Mobile Intel[®] Pentium[®] II Processor Specification Update

Release Date: August 2002

Order Number: 243887-043

Old Mobile Pentium® II Processor in Mini-Cartridge Package Label with Supplier Matrix Mark

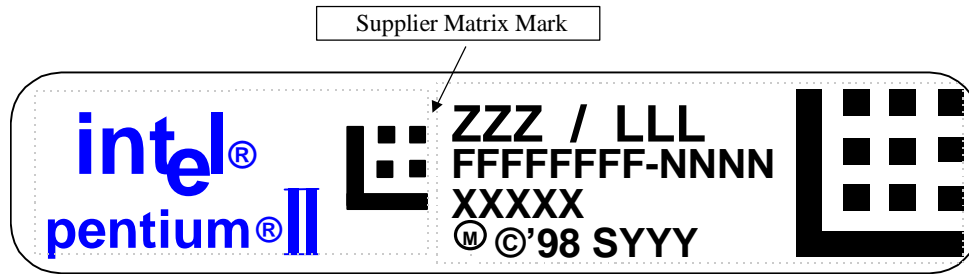
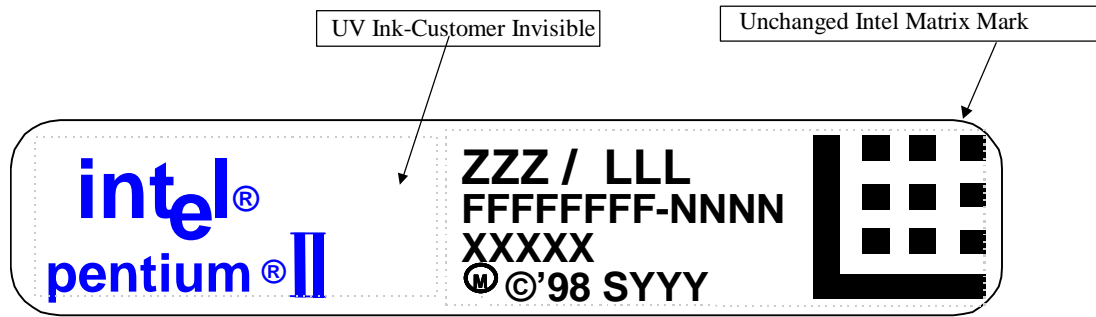
New Mobile Pentium® II Processor in Mini-Cartridge Package Label with Supplier Matrix Mark Removed

Figure 1. V_{CC}/V_{CCP} Timing Requirements (Mobile)

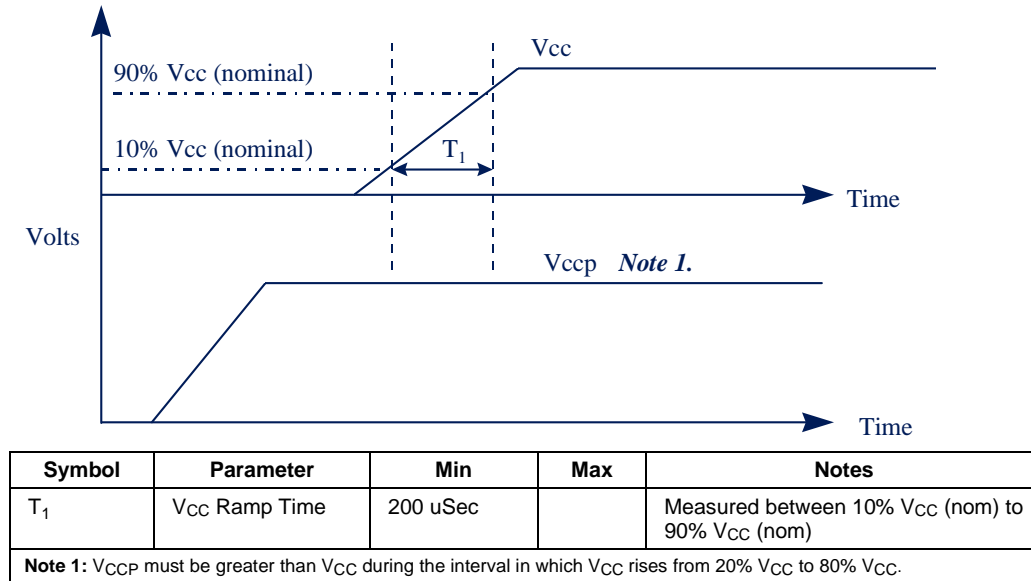
Problem: The processor uses the PWRGOOD signal to ensure that no voltage sequencing issues arise; no pin assertions should cause the processor to change its behavior until this signal is asserted, when all power supplies and clocks to the processor are valid and stable. However, if V_{CC} ramps up before V_{CCP} , it will cause the processor to enter an invalid state.

Implication: If this erratum occurs, the system may boot normally however, the L2 cache may not be initialized.

Workaround: For Mobile Pentium II processors, ensure that V_{CC} ramps after or with the L2 cache IO voltage (V_{CCP}). If V_{CCP} ramps after the V_{CC} , a delay circuit can be placed on the core V_{CC} to ensure that V_{CC} ramps at the same time or after V_{CCP} as shown below in Figure 1.

Figure 2. Workaround Flowchart: SMBALERT#-Driven System

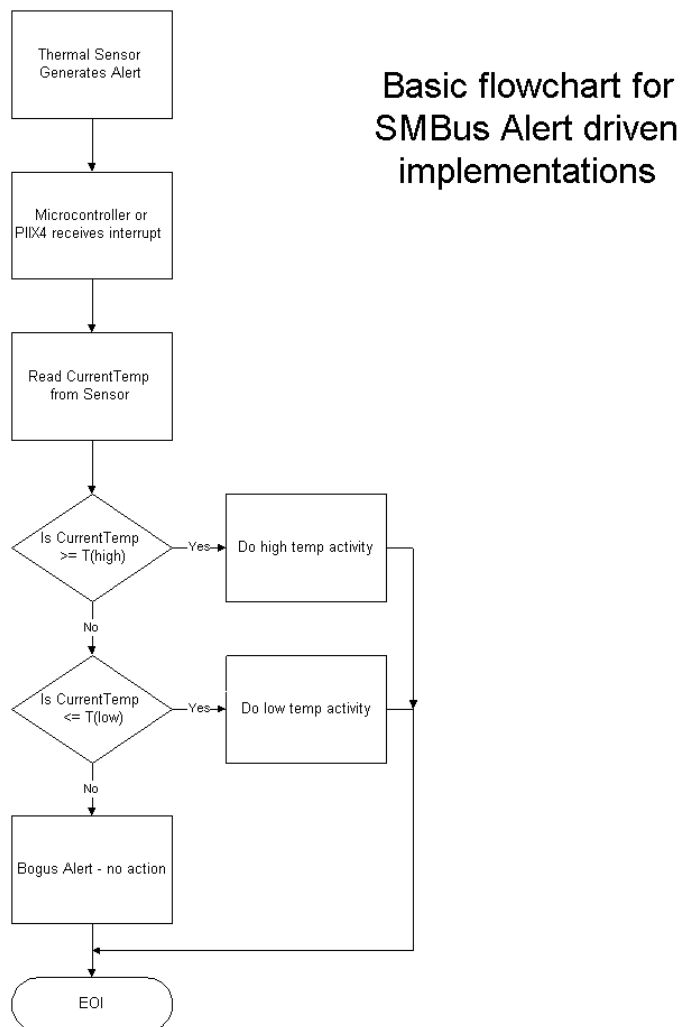
Under the conditions described below, the thermal sensor incorrectly generates the SMBALERT# interrupt. All of the following conditions must be met to trigger a false interrupt:

1. Before servicing an interrupt from the thermal sensor, read and compare the processor thermal reading with the threshold limits (T_{HIGH} or T_{LOW}). Figures 2 and 3 provide basic flowcharts for the implementation of this workaround in an interrupt driven system.
2. If the firmware implemented polls the Status Register only, then before taking any action, re-read the temperature register and do a comparison with the alarm threshold limits (T_{HIGH} or T_{LOW}) to determine if the value is actually still within the temperature window.

3. Use a temperature polling scheme to monitor the processor temperature.

Figure 1. TAP Gageable Thread Clarification

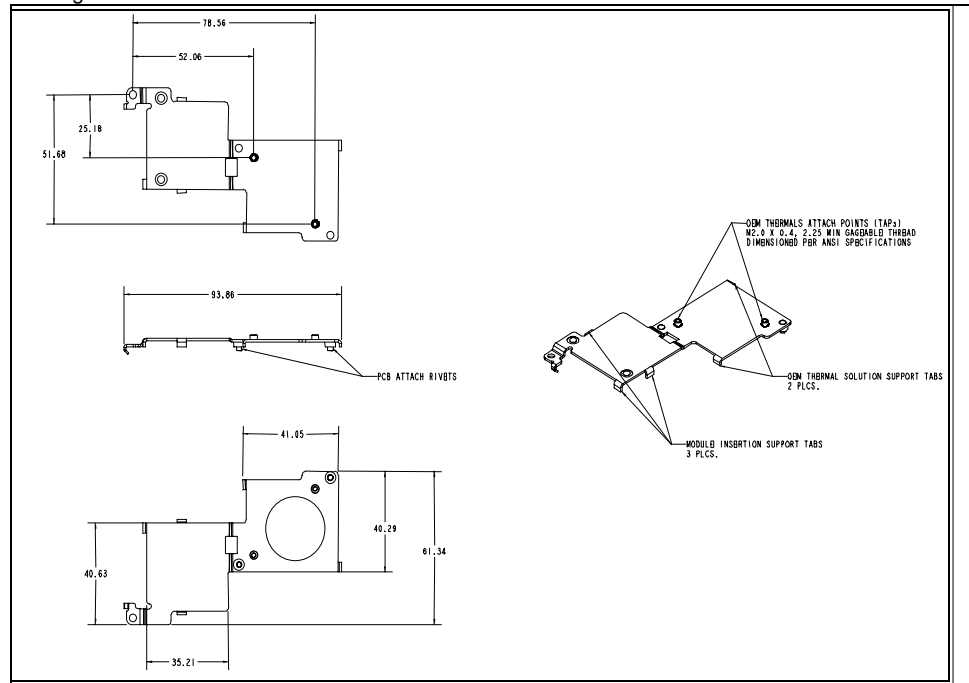
In the *Intel® Pentium® II Processor Mobile Module : Mobile Module Connector 1 (MMC-1)* and the *Intel® Pentium® II Processor Mobile Module : Mobile Module Connector 2 (MMC-2)* datasheets (Order Numbers 243667 and 243668, respectively), the thermal attach point (TAP) gageable thread specification was not clearly identified in Figure 14, of Section 5.2. The following is the TAP clarification:

OEM Thermal Attach Points (TAPs) M2.0 x 0.4, 2.25 min gageable thread dimensioned per ANSI specification.

See Figure 1 below for more information.
